Access Compliance Report

Public Rights-of-Way

Intersection ID: 10031995	Main Street: MONROE_RD	Cross Street: N/A	Location: W
ADA ID: 7133BB3D1031	Ramp Type: Perp	Initial Pass/Fail: Fail	Overall Compliance: No
		Severity Score: 12.5

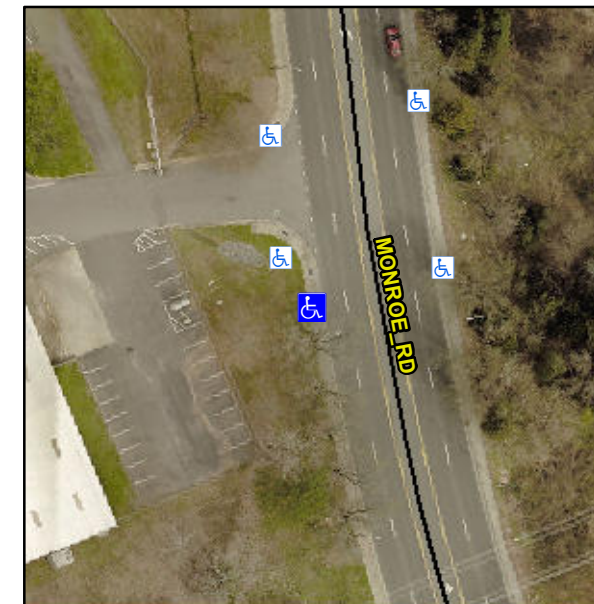
Not Found, R304.2.2

Compliance	Description	Data	Compliance	Description	Data
N/A	Ramp Length (in)	61.0	No	Ramp Slope (%)	8.4
Yes	Ramp Width (in)	48.0	Yes	Ramp XSlope (%)	1.0
N/A	Flare Type LT	N/A	N/A	Flare Type RT	N/A
N/A	Flare Slope LT (%)	N/A	N/A	Flare Slope RT (%)	N/A
N/A	Flare Traversable LT?	N/A	N/A	Flare Traversable RT?	N/A
N/A	Landing Length (in)	N/A	N/A	DWS Provided?	N/A
N/A	Landing Width (in)	N/A	N/A	DWS Contrast?	N/A
N/A	Landing Slope (%)	N/A	N/A	DWS Length (in)	N/A
N/A	Landing X Slope (%)	N/A	N/A	DWS Full Width?	N/A
N/A	Landing Curb? (Y/N)	N/A	N/A	DWS Offset (in)	N/A
N/A	Shared Landing?	N/A			
N/A	Gutter Ponding?	N/A	N/A	Gutter Slope (%)	N/A
N/A	Gutter Lip Ht (in)	N/A	N/A	Gutter X Slope (%)	N/A
N/A	Painted X Walk1?	No	N/A	Painted X Walk2?	N/A
	X Walk 1 Direction	To E		X Walk 2 Direction	N/A
N/A	X Walk 1 Width (in)	N/A	N/A	X Walk 2 Width (in)	N/A
	X Walk 1 Slope (%)	2.0		X Walk 2 Slope (%)	N/A
	X Walk 1 X Slope (%)	0.1		X Walk 2 X Slope (%)	N/A

Remove & Replace Entire Ramp.
